UNITED STATES PATENT AND TRADEMARK OFFICE

APPLICATION NO.	FILING DATE	FIRST NAMED INVENTOR	ATTORNEY DOCKET NO.	CONFIRMATION NO.
10/622,463	07/21/2003	Michio Kitazume	018842.1271	4534

Office Action Summary

DETAILED ACTION

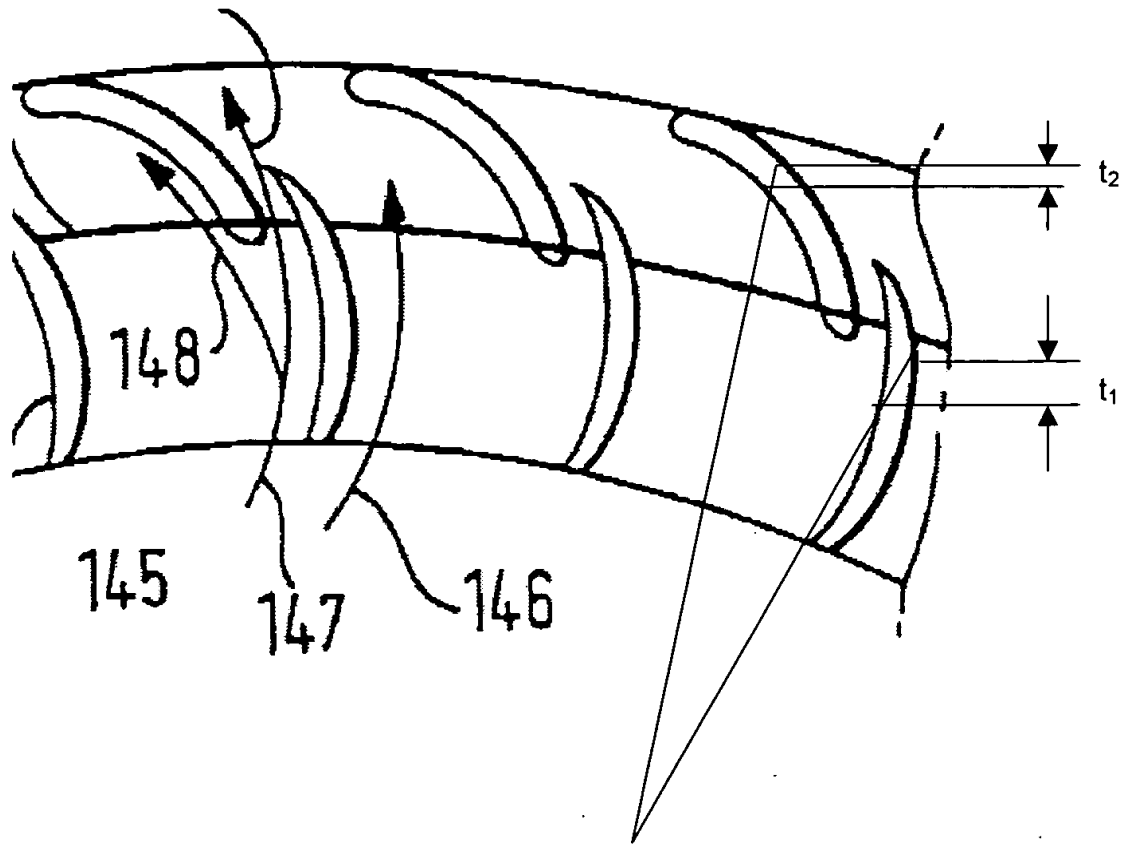
Schwartz et al. teach a sirocco fan for a vehicle air conditioning system having two sets of blades arranged in an alternating pattern. As can be seen in Figure 4 the chord length of the first blades are larger than the chord length of the second blades. And referring to the illustration below, a thickness dimension of the first blade (t_1) is larger than a thickness dimension of the second blade (t_2) in a direction radial from a rotational axis.
